MIT NUCLEAR REACTOR LABORATORY

Re: Massachusetts Institute of Technology; License No. R-37; Docket No. 50-20; Rewrite of Technical Specification for Relicensing

**TECHNICAL SPECIFICATIONS
FOR THE MIT RESEARCH REACTOR (MITR-III)**

Figure 7.1-1: Management Organization

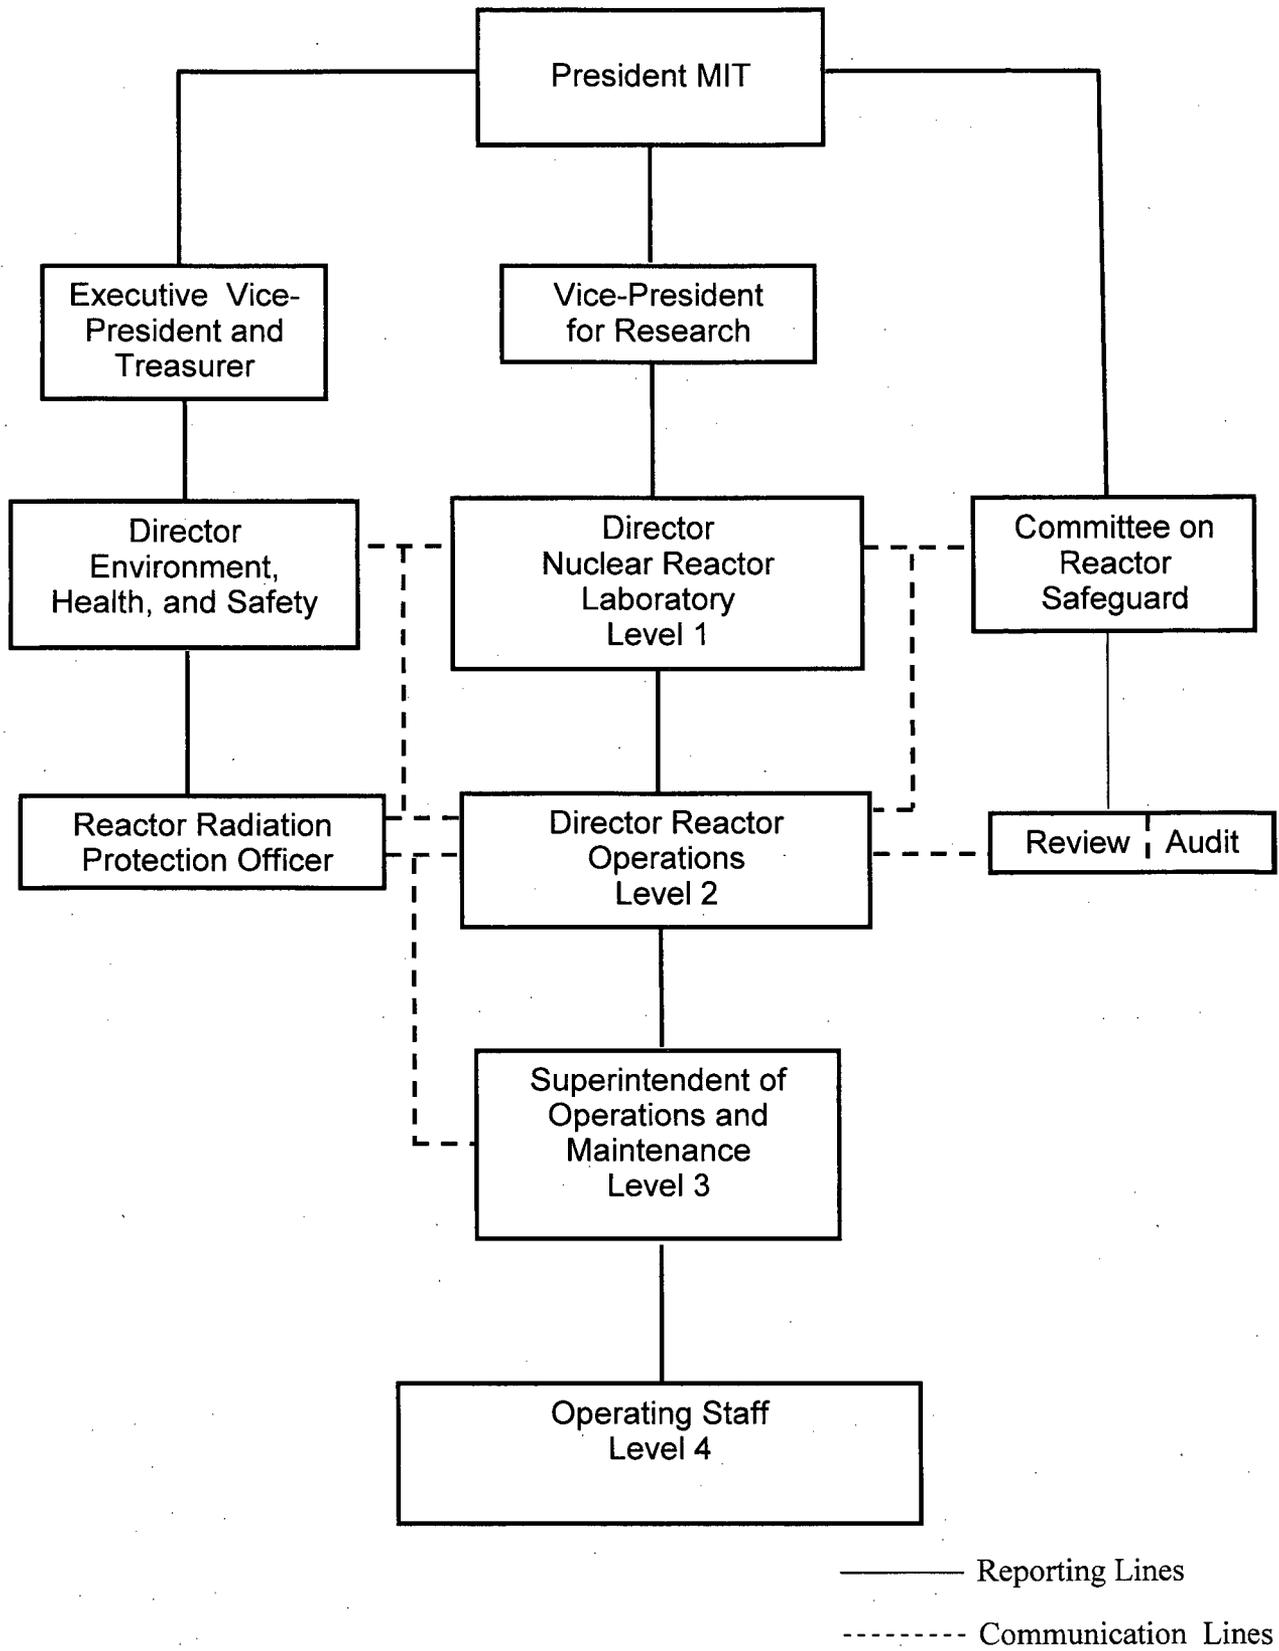
7.1	Figure 7.1-1: The MITR Radiation Protection Office now reports via the Executive Vice President and Treasurer and not the Vice President for Human Resources.
License	Possession limit needs to remain at 40 kg.
